CONFERENCE RECAP

DRAINAGE FILE/ZONE ATLAS PAGE NO.: K 20 DATE: 6/26/87
PLANNING DIVISION NOS: EPC: _____ DRB: _____
SUBJECT: Addn to Four Plex
STREET ADDRESS (IF KNOWN): 124 General Arnold NE
SUBDIVISION NAME: Lot 31 Blk 3 Waggoner DENISON

DRAINAGE PLAN
GARAGE ADDITION TO FOUR-PLEX
 124 GENERAL ARNOLD STREET, N.E.
 ALBUQUERQUE, NEW MEXICO

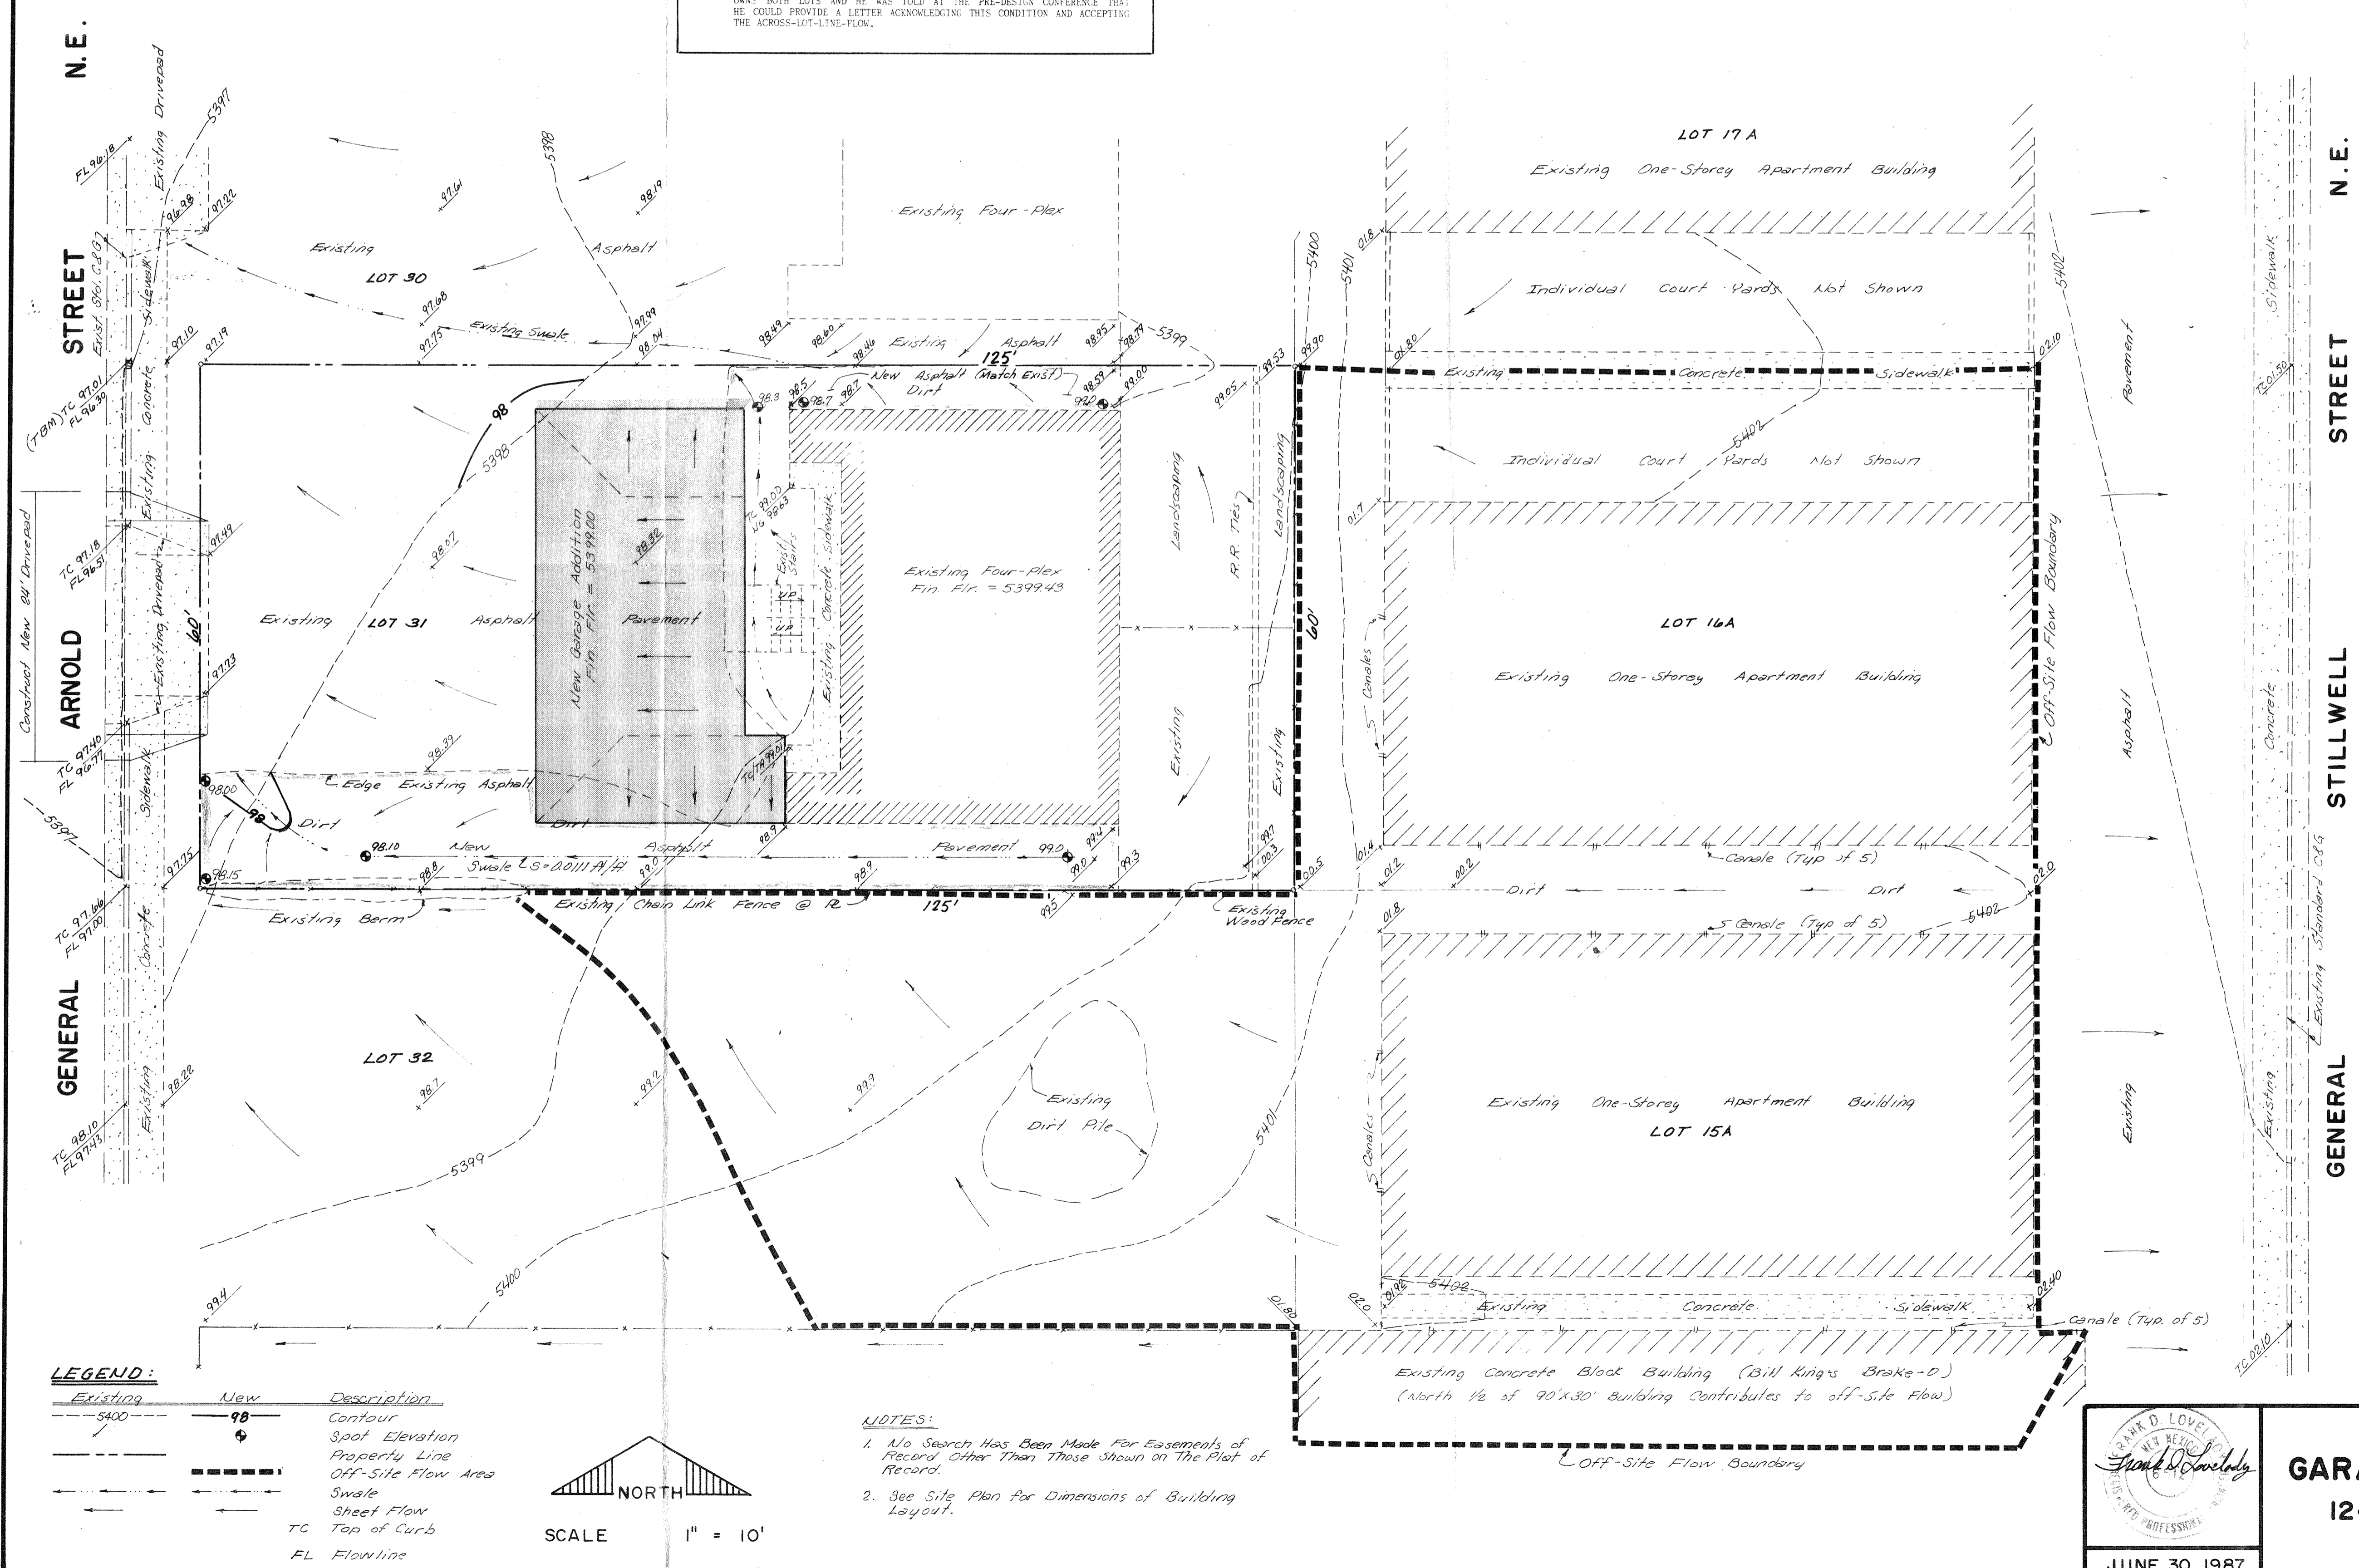
- AN APPROVED DRAINAGE PLAN IS REQUIRED FOR THE PROPOSED ADDITION. THE PLAN WILL NEED TO PROVIDE THE FOLLOWING INFORMATION:
 - EVALUATION OF ANY OFF-SITE FLOW CONDITIONS.
 - SUFFICIENT GRADES ON SITE TO DEMONSTRATE FLOW PATTERNS.
- PONDING REQUIREMENTS CAN BE WAIVED BASED ON THE LATEST AMDS STUDY FOR VOLUME II THAT IS UNDER REVIEW.
- NO OBJECTION TO DRAINAGE OVER SIDEWALK IF THE FLOW CONDITIONS ARE NEGLIGIBLE.

- THE SITE DOES NOT LIE WITHIN OR ADJACENT TO A DESIGNATED FLOOD HAZARD AREA.
- THE FLOODWAY MAP SHOWS FLOODING AT CENTRAL AVENUE AND WYOMING BLVD. HOWEVER, THE LATEST AMDS STUDY FOR VOLUME II SHOWS THAT RECENTLY INSTALLED DRAINAGE FACILITIES HAVE ELIMINATED ANY FLOODING IN THAT AREA.

- THERE IS SOME OFF-SITE FLOW COMING FROM THE APARTMENTS, COMMERCIAL BUILDING AND VACANT LOT EAST AND SOUTH OF THE SITE. IT SHOULD BE NOTED THAT WHEN LOT 32 IS DEVELOPED, THE OFF-SITE FLOW WILL BE REDUCED BY APPROXIMATELY TWO-THIRDS. ALL EXISTING OFF-SITE FLOW IS ACCEPTED. THE EXISTING SITE IS AN INFILL SITE.

- THE GARAGE ADDITION IS TO BE CONSTRUCTED OVER EXISTING ASPHALT PAVEMENT.
- DRAINAGE FROM THE NORTH SIDE OF THE LOT (INCLUDING SOME OFF-SITE FLOW) ENTERS A SWALE THAT IS CENTERED ON THE NORTH PROPERTY LINE. AS IT CLEARS THE APARTMENTS IT CURVES OR TO LOT 30 IN THE DIRECTION OF THE EXISTING DRIVEPAD. THE PORTION OF THE SWALE NEXT TO THE FOUR-PLEX WILL BE PAVED.

- DRAINAGE FROM THE SOUTH SIDE OF THE LOT (INCLUDING THE REMAINING OFF-SITE FLOW) WILL BE TRANSPORTED IN A PAVED ASPHALT SWALE TO THE DRIVE PAD WHICH IS TO BE WIDENED FROM 16 FEET TO 24 FEET WIDE.

- SOME OF THE RUNOFF BETWEEN THE ABOVE-DESCRIBED SWALES WILL CROSS THE SIDEWALK BUT THE QUANTITY WILL BE NEGLIGIBLE AND WILL CROSS AS SHEET FLOW RATHER THAN CONCENTRATED.

- FLOW WILL CROSS THE LOT LINE INTO LOT 30. HOWEVER, THE SAME PARTY OWNS BOTH LOTS AND HE WAS TOLD AT THE PRE-DESIGN CONFERENCE THAT HE COULD PROVIDE A LETTER ACKNOWLEDGING THIS CONDITION AND ACCEPTING THE ACROSS-LOT-LINE-FLOW.
